UNITED STATES PATENT AND TRADEMARK OFFICE

APPLICATION NO.	FILING DATE	FIRST NAMED INVENTOR	ATTORNEY DOCKET NO.	CONFIRMATION NO.
10/036,990	12/31/2001	Ronald L. Edens	17,694	5317

Office Action Summary

Exhibit A

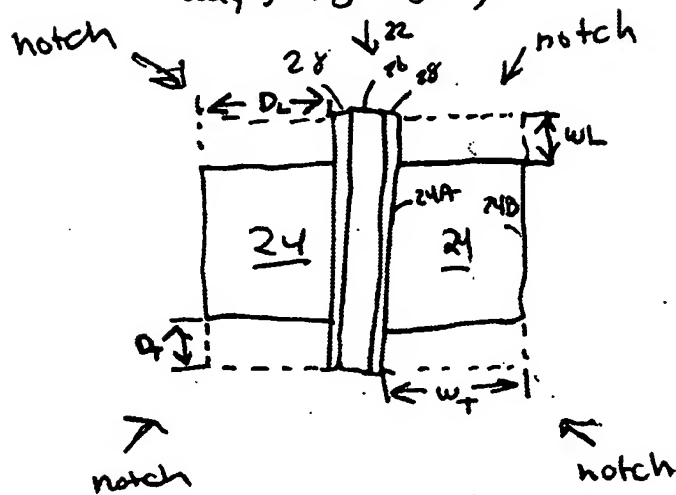
four corners (see attached Exhibit A), which extends through the entire z-axis thickness, extends inward from the periphery to a depth (DT, DL in Exhibit) which depth includes depth of no less than 10 mm but no greater than about 30 mm, i.e. with respect to the depth as measured from the periphery of the transverse end area, DT, see the portions of '609 cited previously in this sentence and with respect to the depth as measured from the periphery of the longitudinal side, i.e. the distance from 24B to 24A or DL, see page 16, lines 24-29 and thereby page 8, lines 25-27. The notch also includes a width (WT, WL in Exhibit) which is no less than about 15mm but no greater than about 30 mm, i.e. with respect to the width as measured along the periphery of the transverse end area, WT, see width of 22 along T or y and page 8, line 22 and with respect to the width as measured along the periphery of the longitudinal side, WL, see page 8, lines 15-19, page 16, lines 19-24 and page 20, last paragraph. With respect to claims 10 and 24, one of the notches can be considered the notch in the longitudinal side and another one of the notches can be considered the notch in the transverse end area.
